Stinson Division
Consolidated Vultee Aircraft Corporation
Wayne, Michigan

TITLE: Replacement of "Click" Washer in
Fuel Valve

BULLETIN NO. 250

MODELS AFFECTED: 108 (Voyager and Flying
Station Wagon - 165 H. P.
Serial Numbers 108-2250
through 108-2652

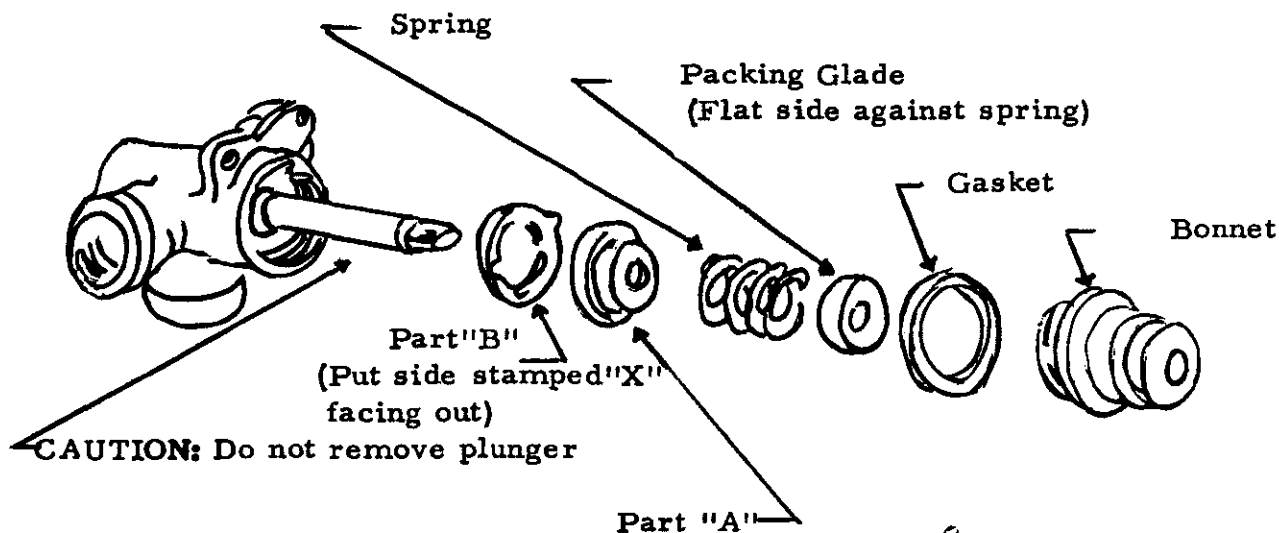
In order to restore the position locating feature in the fuel tank selector valve and assure positive operation of the valve at all times, it is recommended that the subject replacement be made in all 165 horsepower voyager and Flying Station Wagon airplanes within the serial numbers noted above.

Necessary parts, marked "A" and "B" on Figure 1, are being forwarded under separate cover without charge.

Drain the fuel from both tanks and drain the fuel lines at the strainer on the firewall. Disconnect control shaft from fuel valve. Remove bonnet from valve and disassemble valve to the extent shown in Figure 1. Parts "A" and "B" are to be replaced with the new parts furnished. Reassemble valve and attach control shaft. When reinstalling part "B" position the tab in the groove off-set to the right. The side of the washer marked "X" should face out of the valve. **IT IS IMPORTANT THAT THE TAB BE INSTALLED IN THE GROOVE OFF-SET TO THE RIGHT OTHERWISE THE VALVE POSITION INDICATOR WILL NOT INDICATE CORRECTLY.**
